PALISADES PLANT
CONSUMERS POWER COMPANY

PIPING DRAWING AREA 3
SECTIONS

JOB No.	DRAWING No.	REV.
5935	M-42	32

M-42

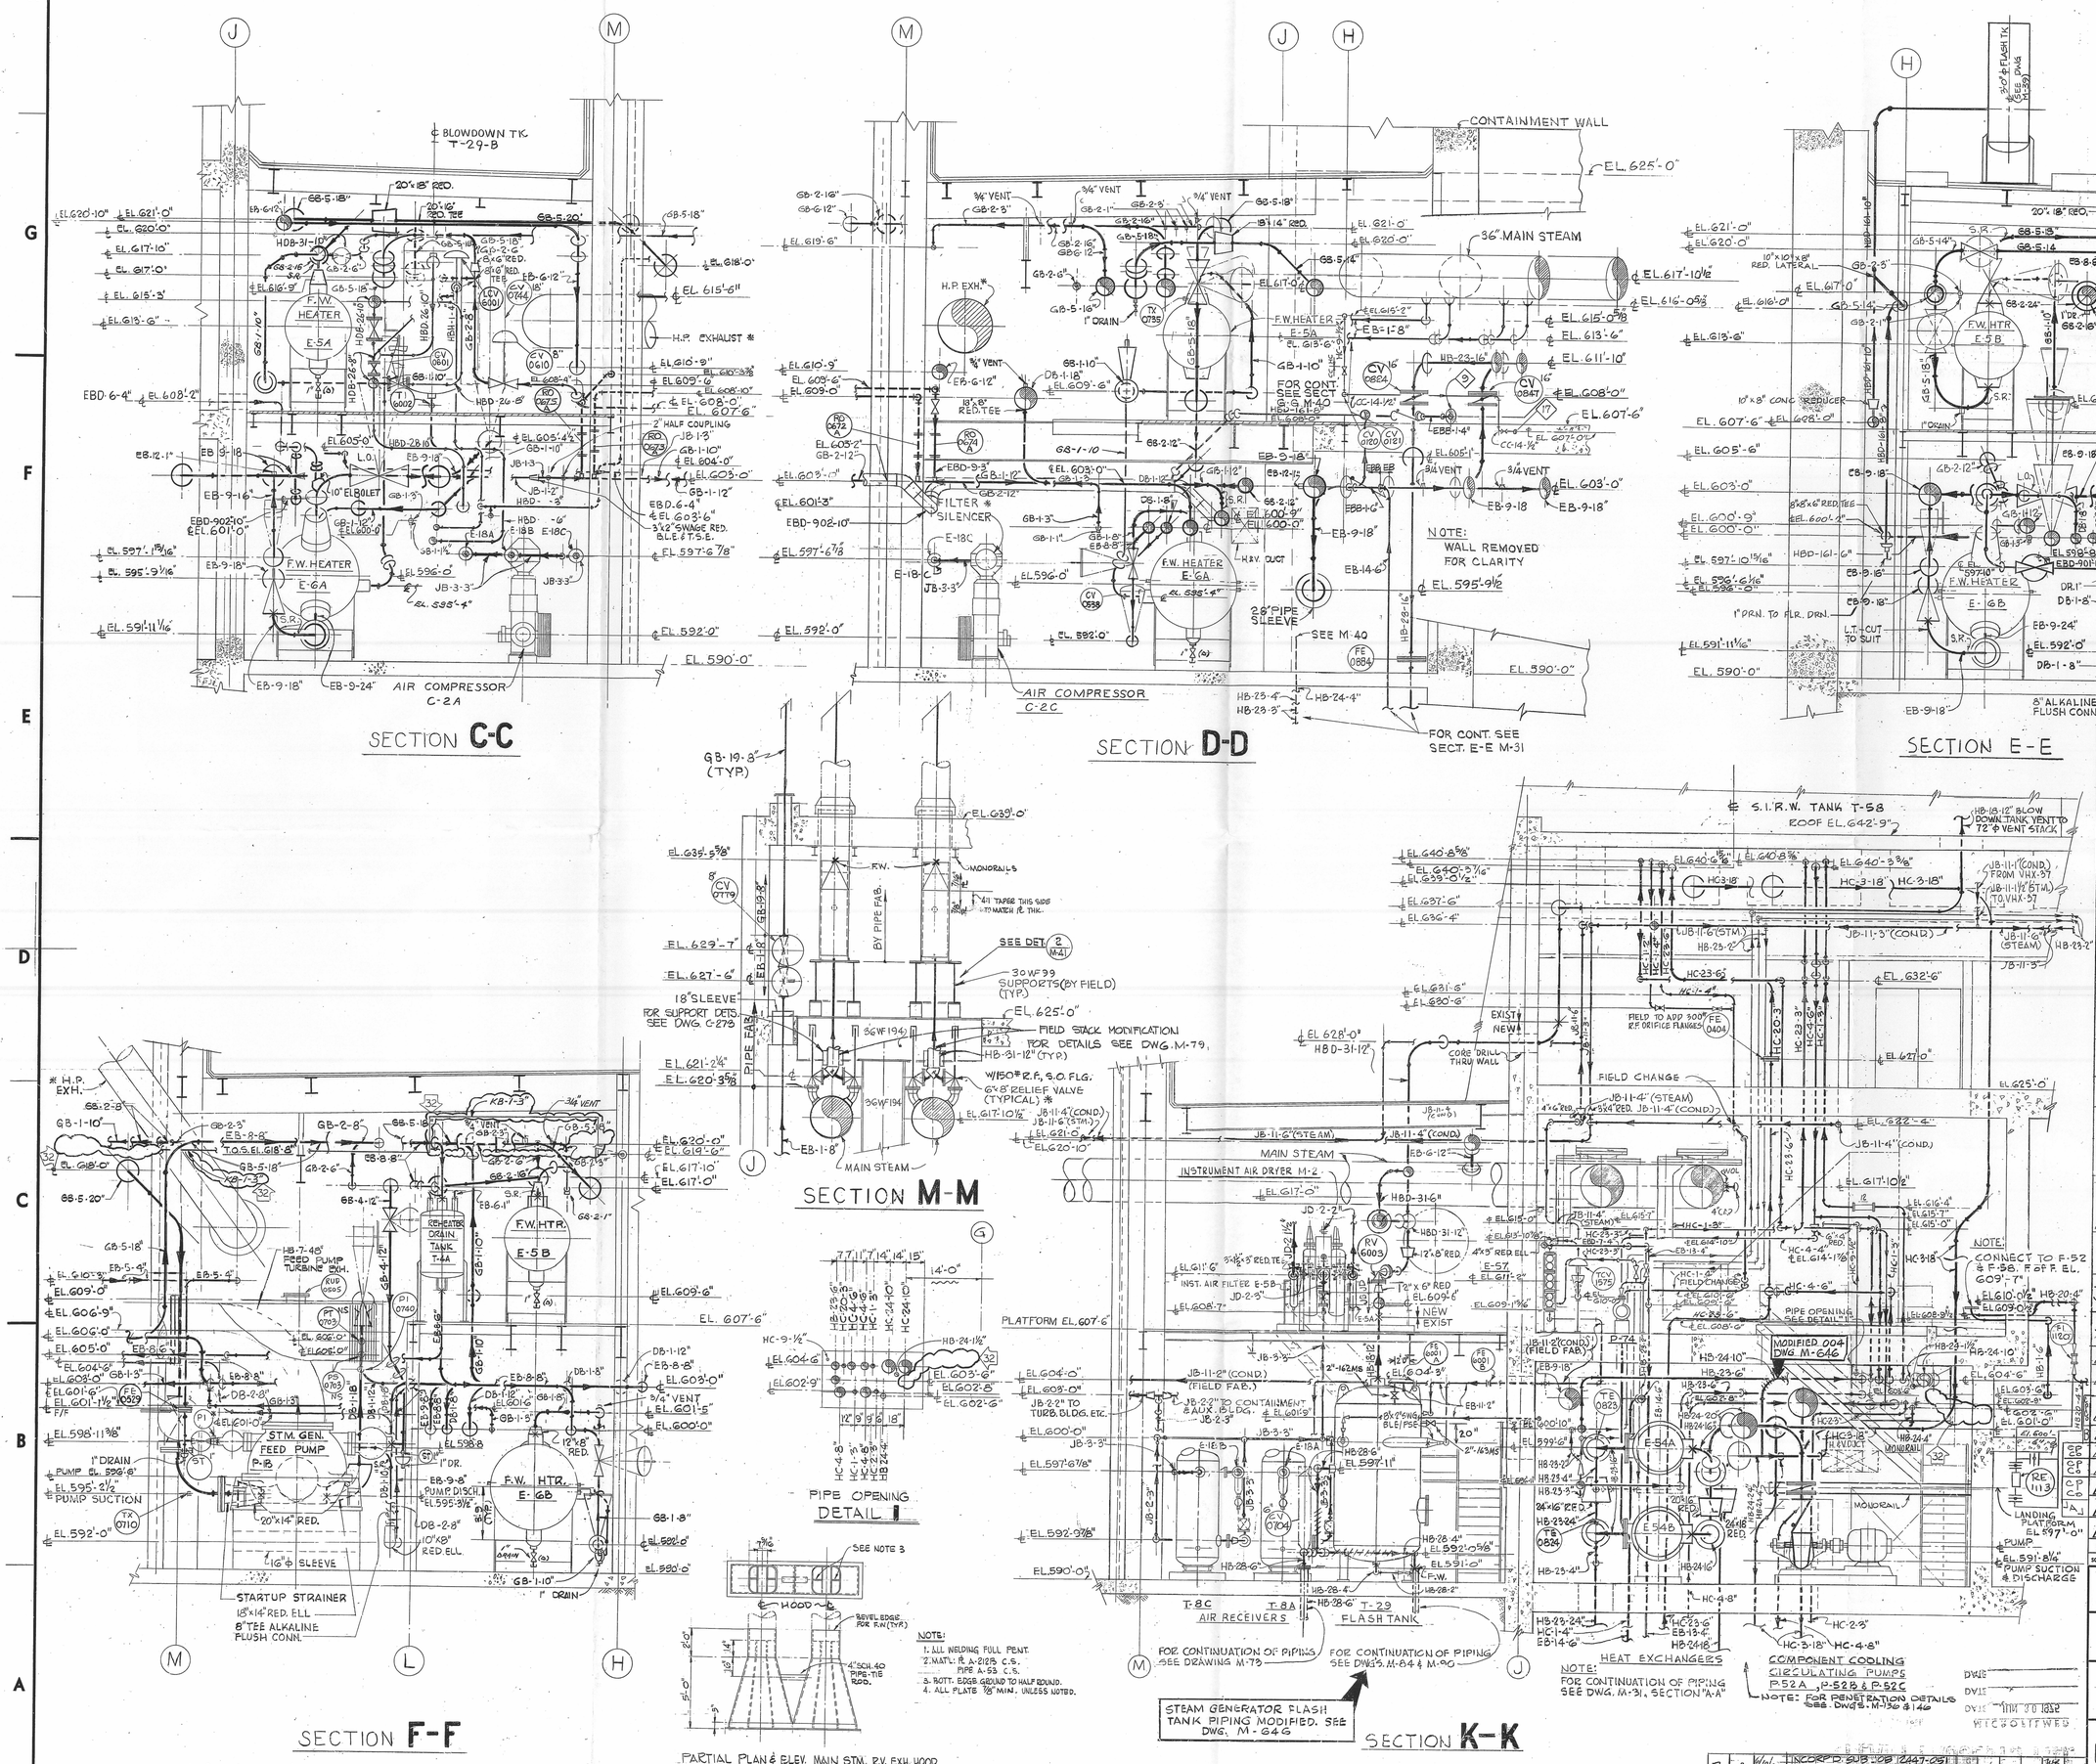
No.	DATE	REVISIONS	BY	CHK	DFTG. SUPVR.	ENGR.	PROJ. ENGR.	CHIEF ENGR.
20A	2/23/79	CHANGED T-29 TO FLASH TK. ADDED BLOWDOWN TK. T-29B & LINES HBD-26, 28 & 31	LHM					
19	11-30-73	DELETED LINE EB-45-4" & ADDED LINE EBD-6-4" @ E-7	GL	JFK				
18	9-14-72	MU STEAM R.V. SIDE MODIFICATION ISSUED FOR FIELD CONSTRUCTION	DR					
17	5/19/72	REPLACED EQUAL VENTS EB-6 WITH EBD1 & EBD-3. ADDED 2-4" NOZZLES ON T-6A	GL					
16	11/1/71	REVISED FEED PUMPS RECIRC. LINES DB-2-8" @ B-B & F-1	GL					
15	8/5/71	CHANGED LINE SIZE FROM 6" TO 8" DB-2-8". F-1 & B-B.	LB					
14	4-30-70	HOLD ON HC04, HC46-4" PIPING	FSC					
13	10/10/69	ADDED HC-45-4" ON SECT. K-K. ADDED HB-28-4" & HB-28-2" @ STM. GEN. BLOWDOWN TANK. REROUTED HB-23-6" @ SECT. K-K. (BY FIELD)	FSC					
12	8/15/69	ADDED PARTIAL PLAN & ELEV. OF MAIN STM. R.V. EXH. HOOD & NOTES ADDED PARTIAL SECTION "Y-Y" REV. SECTION "M-M" REV. MONORAIL LOCATION ON SECT. "K-K"	FSC

11	5/5/69	REVISED HB-23-16" (BY FIELD) ADDED: MONORAIL OVER PUMPS P-1A, B & ADDED DRIP FE 0404 IN LINE HC-23-6"	HP					
10	3/28/69	REVISED HC-1-4", HC18-3" & HC4-8" FIELD TO MODIFY PIPING AND ADD SEALS.	HP					
9	2/27/69	CHANGED LINE NO. FROM HB-1-4" TO HB-20-4". REVISED EB-13-4" @ SECT. K-K. ADDED TEST CONN. @ JB-16-4" SECT. EL. DELETED KB-1-6" @ SECT. C-C.						
8	11/25/68	ADDED KB-1 FIRE SYSTEM						
7	11/15/68	REVISED E-57 & PIPING. DELETED HC-23-1". ADDED P-74, HC-4-4", HC1-3", HC-23-3", HB-24-1 1/2", HC-9-1/2", CC-14-1/2", EB-11-2", & HB-23-2". REVISED JB-11-3 (WAS 4") ADDED JB-11-1 1/2" (STM.) & JB-11-1 (COND) FOR V.W.S.T. REVISED KB-1-3, BECOMES KB-1-2"						
6	10/2/68	REVISED JB-11-4" (STM. & COND.) HC1-4" INCORPORATED DCN 4". ADDED HB-23-6, HB-28-6", CV-0704 & CV-0778B, EB-1-8" & GB-2-8". REMOVED HOLD FROM INSTRUMENT AIR DRYER & FILTERS.						
32	2-23-96	REMOVE KB-1-2" IN DETAIL 1 & SEC. K-K REVISE KB-1-2" IN SEC. F-F PER DCR-95-1366

31	4-2-92	ADD RV 6003, E-61, E-58, E-51 AND E-58 PER GMD 0403 / FC 875 / DCR 380-91-382 (MOD)						
30	3/13/90	REVISED SECTION D-D & SECTION E-E PER FC-850 & 850-90 DCN 0484 (MOD)						
29	7/23/87	REMOVED REV 4 DELETED SECTION L-L REVISED PER FC-510-5						
28	7/29/82	ADDED DRAINS EBD-9-3 FROM MSR E-5A, E-6B & E-6A. OD, GMD 0408						
27	8/20/78	THIS DWG. SUPERCEDES M-9042-ISSUED FOR RECORD REMOVED REV. 3						
26	11-10-76	CORRECTED DIMENSION TO 163-MS						
25	10-20-76	REVISED PER FC #272						
24	7-20-76	AS BUILT - ADDED 162-MS & 163-MS PER FC. 322						
23	4-19-76	REROUTE EBD-7-4" GMD 7639						
22	10/22/74	ADDED T1-6002 @ F-7 & REV. EBD-7, HBD-26, 28, 31 & JB-11, ISSUED AS-BUILT

NO	DATE	REVISIONS	BY	CHK	DFTG. SUPVR.	ENGR.	PROJ. ENGR.	CHIEF ENGR.
B	8/10/82	INCORP'D SUB-JOB 1247-051 (EBD-1-12) PER GMD 0852 & ISSUED FOR RECORD
